# HISTORIC AND DESIGN REVIEW COMMISSION

August 17, 2022

**HDRC CASE NO:** 2022-421  
**ADDRESS:** 209 W POPLAR ST  
**LEGAL DESCRIPTION:** NCB 372 BLK 10 LOT E 13 FT OF 11 & W 36.04 FT OF 12  
**ZONING:** C-1, HL  
**CITY COUNCIL DIST.:** 1  
**LANDMARK:** Individual Landmark  
**APPLICANT:** xavier gonzalez/grg architecture  
**OWNER:** Jason Sagebiel/STARSPERTY HOLDINGS LLC  
**TYPE OF WORK:** Front porch enclosure  
**APPLICATION RECEIVED:** July 29, 2022  
**60-DAY REVIEW:** Not applicable due to City Council Emergency Orders  
**CASE MANAGER:** Rachel Rettaliata

The applicant is requesting a Certificate of Appropriateness for approval to enclose the east side of the 2-story front porch.

MODIFIED PORCH FLOOR PLAN

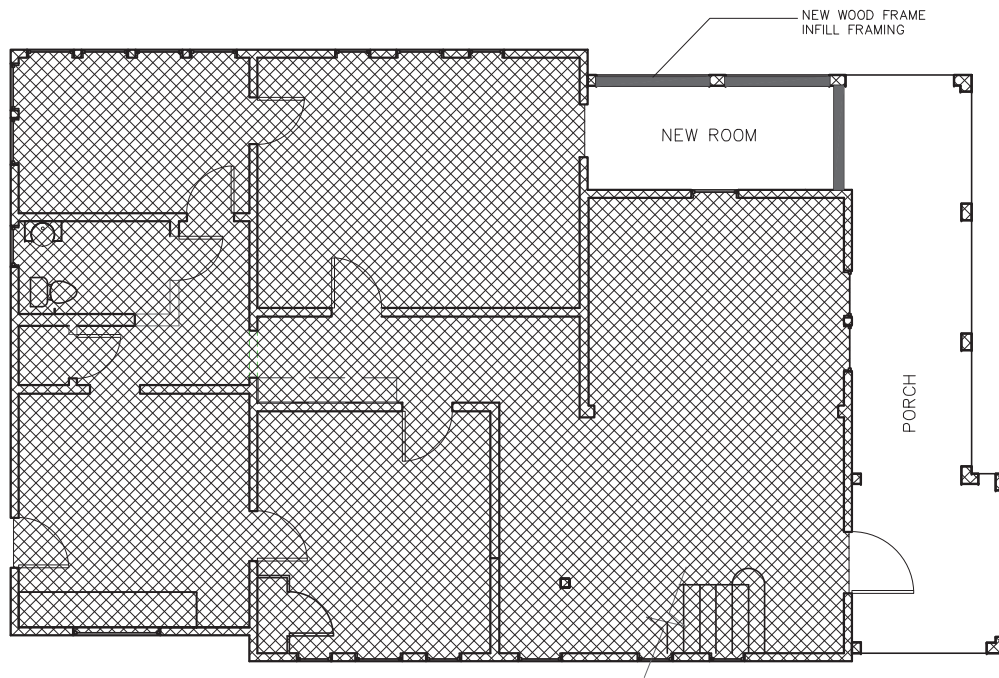
- b. PORCH ENCLOSURE – The applicant has proposed to enclose the east side of the 2-story front porch and construct a front addition flush with the existing porch columns. The existing 2-story front porch is original to the structure in its existing configuration. The applicant has proposed to enclose this portion of the front porch by infilling wood framing between the existing porch columns and installing horizontal smooth Hardie siding. The applicant has proposed to paint the porch infill a lighter color than the existing siding. Additionally, the applicant has proposed to remove the existing non-original porch balustrade at the second story to accommodate the porch enclosure. The applicant has expressed that the porch enclosure is designed for reversibility and could be easily removed in the future. Guideline 7.B.i for Exterior Maintenance and Alterations states that applicants should refrain from enclosing front porches. Additionally, Guideline 7.B.v for Exterior Maintenance and Alterations recommends that porches are reconstructed based on accurate evidence of the original, such as photographs. The 1904 Sanborn Map shows that the existing footprint of the front façade and front porch is original to the structure. Staff finds the proposal inconsistent with the Guidelines.

Staff does not recommend approval of enclosing the front porch and constructing a front façade addition based on findings a through b.
